SUBJECT: Reply to Notice of Violation – Clarification of Information  
Grand Gulf Nuclear Station, Unit 1  
Docket No. 50-416  
License No. NPF-29

**Reply to Notice of Violation – Clarification of Information**

Main Steam Line Radiation Monitors

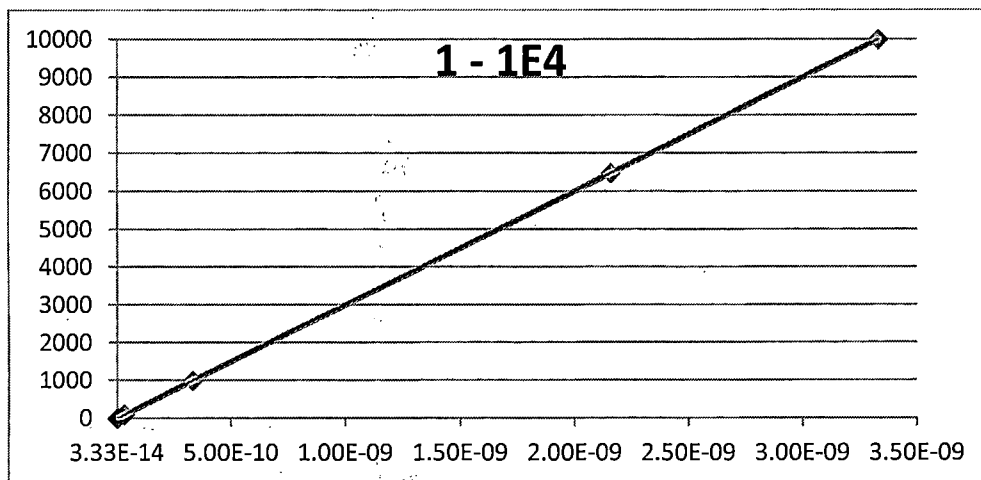
6. When two points are used to establish response to a range of radiation levels, the linear relationship of the detected points needs to be stated and supported by evidence.

Linearity applies to the Main Steam Line Monitors only. Two radiation source calibration data points are plotted on the electronic calibration results line.
